Access Audit Site Report

Longhorn Cavern State Park

Accessibility Evaluation

Inspection Date: 08/24/2021

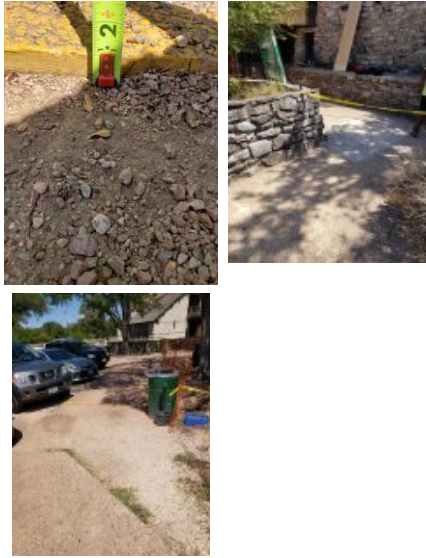
Finding Number	Area Description	Lat/Long	Finding	As Built	Recommendation	Citation	Photos	Figure
4	Visitor Center: Visitor Center Parking	[30.68459, -98.351077 6]	The parking sign is mounted too low. Parking space identification signs shall include the International Symbol of Accessibility complying with. Signs identifying van parking spaces shall contain the designation "van accessible." Signs shall be 60 inches minimum above the finish floor or ground surface measured to the bottom of the sign.	parking sign 50.5"	Raise existing accessible parking signs so lowest end of bottom sign is min 60" aff	2015 ABAAS Section: 502.6 2012 TAS Section: 502.6 2010 ADAS Section: 502.6

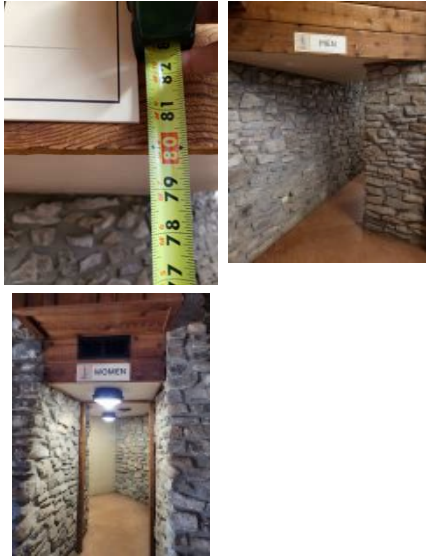
Finding Number	Area Description	Lat/Long	Finding	As Built	Recommendation	Citation	Photos	Figure
10	Visitor Center: Visitor Center Employee Spaces	[30.68462, -98.35115]	Minimum maneuvering clearances at doors and gates shall comply with 404.2.4. Maneuvering clearances shall extend the full width of the doorway and the required latch side or hinge side clearance. Hand-activated door opening hardware, handles, pulls, latches, locks, and other operating devices on accessible doors shall have a shape that is easy to grasp with one hand and does not require tight grasping, tight pinching or twisting of the wrist to operate. Hardware shall be 34 inches minimum and 48 inches maximum above the finish floor or ground.	employee room-storage push side, knob hardware	For all doors along the public circulation route, provide required maneuvering clearance on push and pull side of doors For all doors along the public circulation route, replace hardware with lever hardware or hardware operable without a tight pinch or grasp	2010 ADAS Section: 404.2.3, 404.2.7, 404.2.4, 404.2.11, 404.2.11 Exception

11	Visitor Center: Visitor Center Employee Spaces	[30.68462, -98.35115]	Minimum maneuvering clearances at doors and gates shall comply with 404.2.4. Maneuvering clearances shall extend the full width of the doorway and the required latch side or hinge side clearance. The sweep period for doors with closers shall be adjusted so that from an open position of 70 degrees, the door will take at least 3 seconds to move to a point 3 inches from the latch, measured to the leading edge of the door. Hand-activated door opening hardware, handles, pulls, latches, locks, and other operating devices on accessible doors shall have a shape that is easy to grasp with one hand and does not require tight grasping, tight pinching or twisting of the wrist to operate. Hardware shall be 34 inches minimum and 48 inches maximum above the finish floor or ground.	employee room 2-desk pull side, hardware 31.25", closes fast	For all doors along the public circulation route, provide required maneuvering clearance on push and pull side of doors For all doors along the public circulation route, inspect, adjust, and maintain closing speed on door closers For all doors along the public circulation route, remount hardware to be 34" to 48" aff	2010 ADAS Section: 404.2.3, 404.2.7, 404.2.4, 404.2.11, 404.2.11 Exception

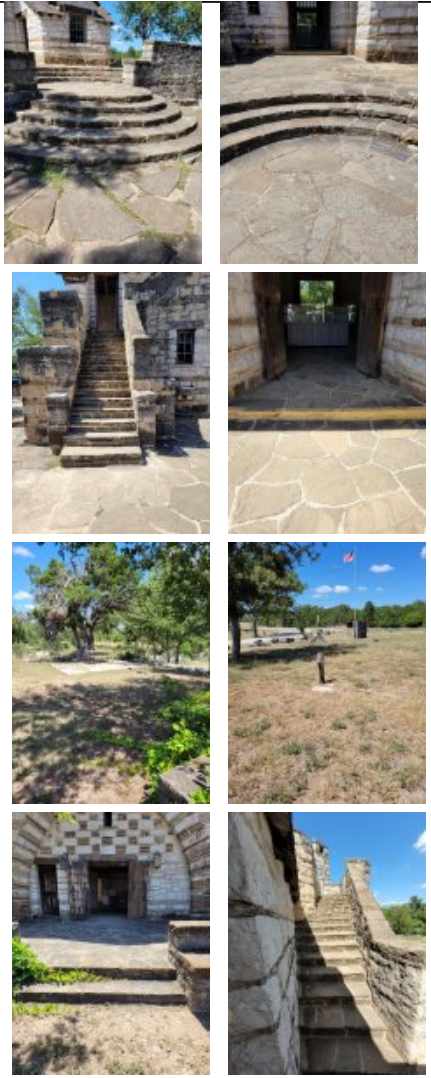
Finding Number	Area Description	Lat/Long	Finding	As Built	Recommendation	Citation	Photos	Figure
18	Visitor Center: Visitor Center Public Spaces	[30.6844032 , -98.350881 8]	Element meets all standards and requirements	Bench in back of building meets all standards and requirements	None	2010 ADAS Section: N/A		
19	Visitor Center: Visitor Center Public Spaces	[30.6843593 , -98.351045 4]	Picnic tables shall provide at least one wheelchair space for each 24 linear feet (7320 mm) of usable table surface perimeter. Wheelchair spaces shall be 30 inches (760 mm) minimum by 48 inches (1220 mm) minimum. Wheelchair spaces shall be positioned for a forward approach to the table and provide knee and toe clearance complying with 306 under the table	4 of 4 tables on the patio are not of an accessible design	Replace picnic table with one of an accessible design as a smart practice	2015 ABAAS Section: 1011.4.2

20	Visitor Center: Visitor Center Public Spaces	[30.6842371 , -98.350932 7]	There is no accessible route to the 2 picnic tables, white chairs, and small table. At least one accessible route shall connect accessible buildings, accessible facilities, accessible elements, and accessible spaces that are on the same site.	Lacks accessible route to 2 picnic tables (not accessible design), white chairs, and small table	Create an accessible route with crushed stone or other outdoor material from parking or walkway to the 2 picnic tables, white chairs, and small table Replace one picnic table with one that is of an accessible design as a smart practice	2015 ABAAS Section: F206.2.2 2012 TAS Section: 206.2.2 2010 ADAS Section: 206.2.2

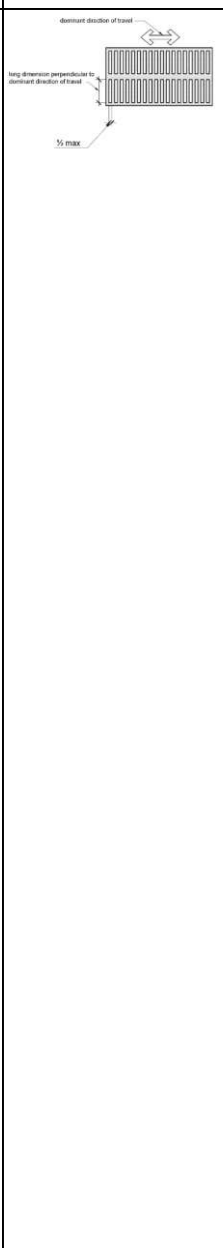
Finding Number	Area Description	Lat/Long	Finding	As Built	Recommendation	Citation	Photos	Figure
33	CCC Observation Tower: CCC Observation Tower	[30.6839303 , -98.352448 2]	There is no accessible route to 14 picnic tables, 3 garbage cans, and 1 fire ring. At least one accessible route shall connect accessible buildings, accessible facilities, accessible elements, and accessible spaces that are on the same site.	Lacks accessible route to 14 picnic tables, 3 garbage cans, and 1 fire ring	Create an accessible route with crushed stone or other outdoor material from parking or walkway to 3 picnic tables, 1 garbage can, and 1 fire ring	2015 ABAAS Section: F206.2.2 2012 TAS Section: 206.2.2 2010 ADAS Section: 206.2.2
